## **NOTICE OF A TYPE II<sub>x</sub> DECISION ON A PROPOSAL IN YOUR NEIGHBORHOOD**

### **CASE FILE NUMBER: LU 14-253755 LDS**

The applicant proposes to divide the 46,724 square foot site to create 8 lots for single dwelling development and two open space tracts. The proposed lots range in size from 3,000 to 8,179 square feet. The existing house will be retained on Lot 3. The garage will be removed and a replacement parking pad installed for the house.

RECEIVED  
FEB 18 2000  
14-253755  
C.3

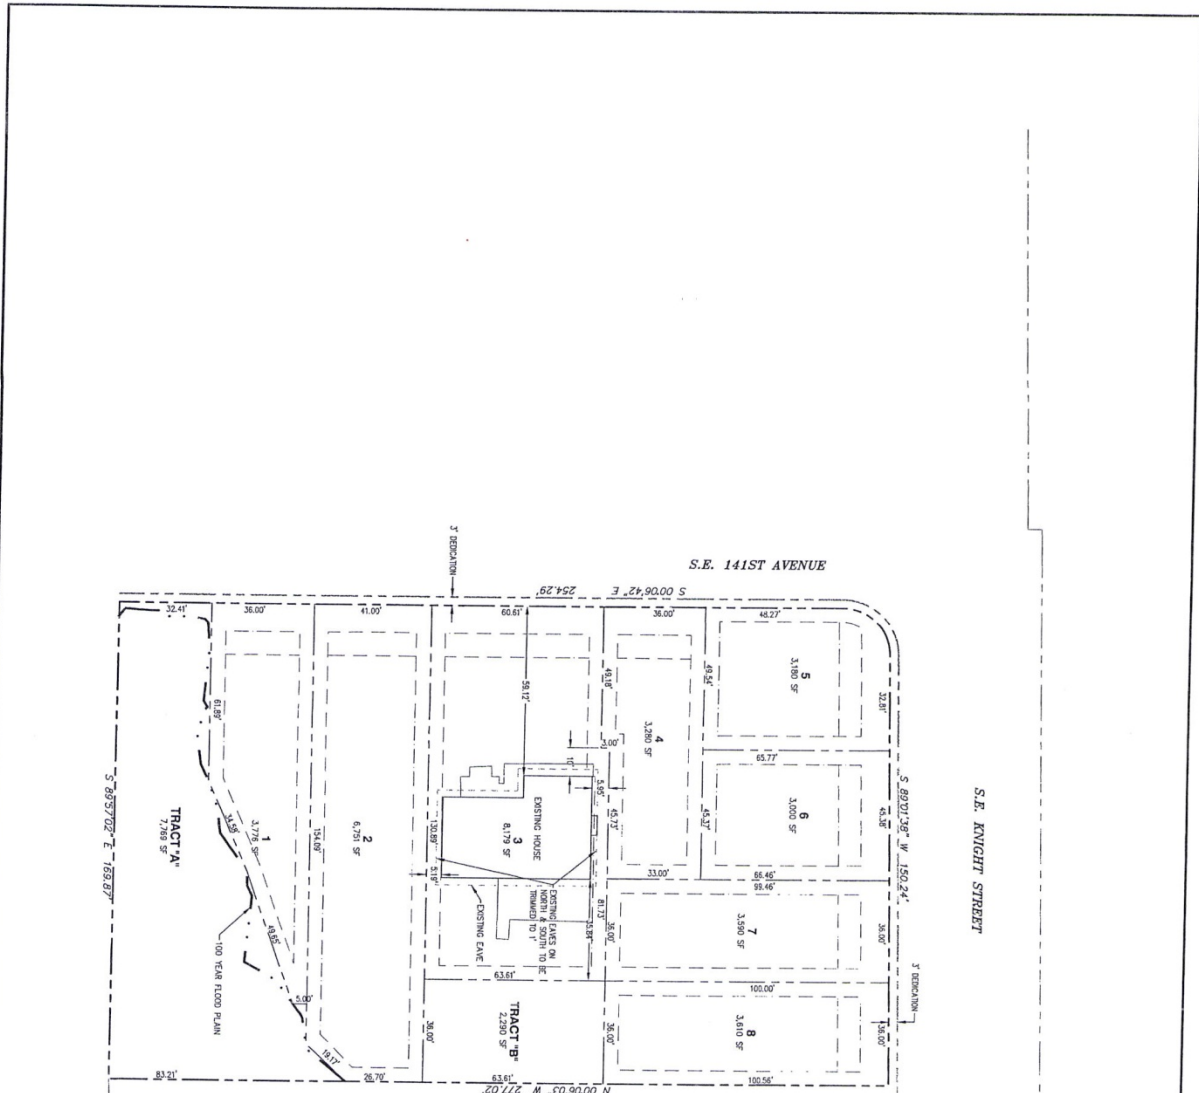
The findings above show that the applicable density and lot dimension standards are met. It should be noted that a minor revision to the Lot 4 dimensions are required to comply with the minimum width standard of 36 feet measured at the minimum front setback (10 feet) and 40 feet back. The applicant's plans show a small jog in the lot line at 49.18 feet. The side lot line must be straight for at least 50 feet to meet the minimum width requirement. There is flexibility to make this adjustment between Lots 3 and 4 on the final plat, as noted on Exhibit C.3. This criterion is met.

Note: Minor change to Lot 4 width required to meet lot dimension stds (see decision findings).
